ADDENDUM #1 - 6/16/2025
REVISED SHEETS: D-1, D-2, D-7, INT-2, INT-3, P-1, P-2, P-4, U-1, U-2, U-3, U-5, W-1, W-2, W-5, W-7, E-1, E-2, E-4, E-7, AND E-8.
REVISION #1 - 8/28/2025
REVISED SHEETS: D-6, INT-2, INT-3, INT-4, INT-6, INT-7, P-1, P-2, P-3, P-4, P-5, P-6, U, W, E, AND ALL X SHEETS.
REVISION #2 - 11/10/2025
REVISED SHEETS: D-6, D-7, INT 1 - INT 4, INT-6, P-1, P-2, P-4, U-1 - U-7, U-12 - U-15, W-3, X-1 - X-7, X-9, AND X-10.

CITY ENGINEERING DIVISION
DEPARTMENT OF PUBLIC WORKS
PLAN OF PROPOSED IMPROVEMENT

E. MAIN STREET & S. HANCOCK STREET
ASSESSMENT DISTRICT - 2025

CITY PROJECT NO. 15125
CONTRACT NO. 8784

X-13

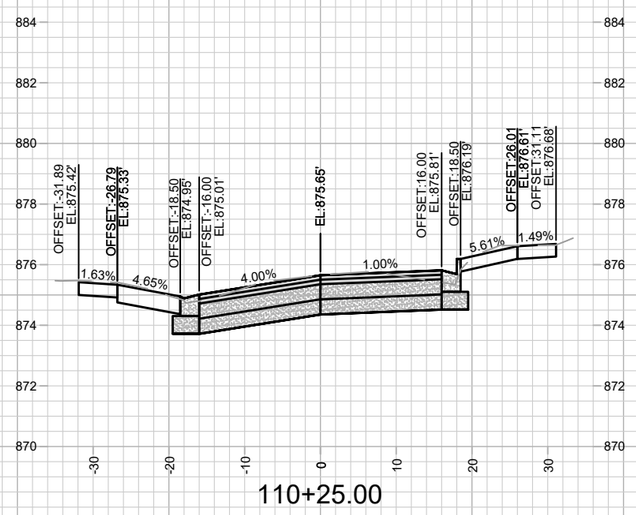
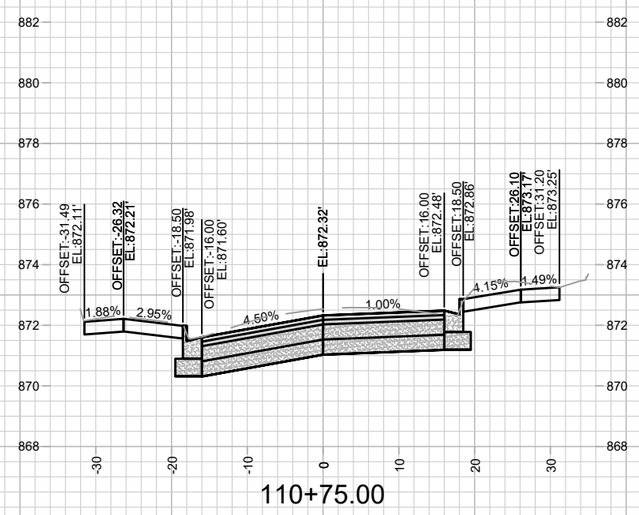
REVISION #1 - 8/28/2025
ADJUSTED HANCOCK ST CENTERLINE GRADES.
